Access Compliance Report

Public Rights-of-Way

Intersection ID: 53017	Main Street: STEEL_HOUSE_BV	Cross Street: CHARTRES_LN	Location: NW
ADA ID: 194C250B4C70	Ramp Type: BlendTrans1	Initial Pass/Fail: Pass	Overall Compliance: No
		Severity Score: 10

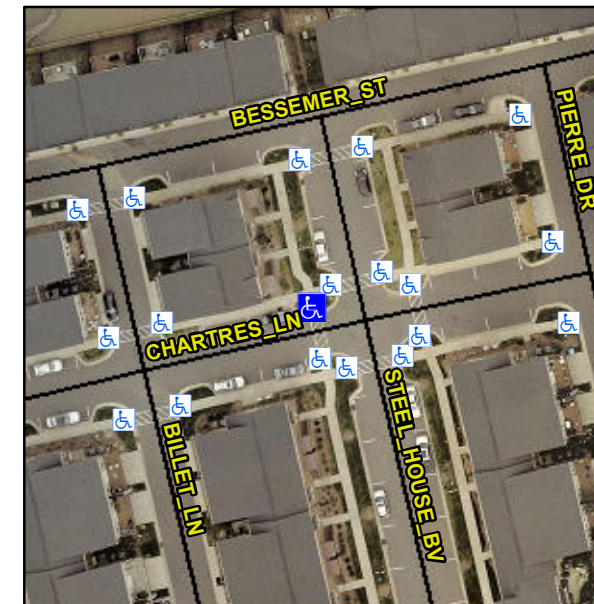
Not Found, R305.1.4, R305.2, R302.7.2, R304.5.3

Remove & Replace Curb Ramp With Two New Directional Ramps or Equivalent. Remove & Replace Gutter.
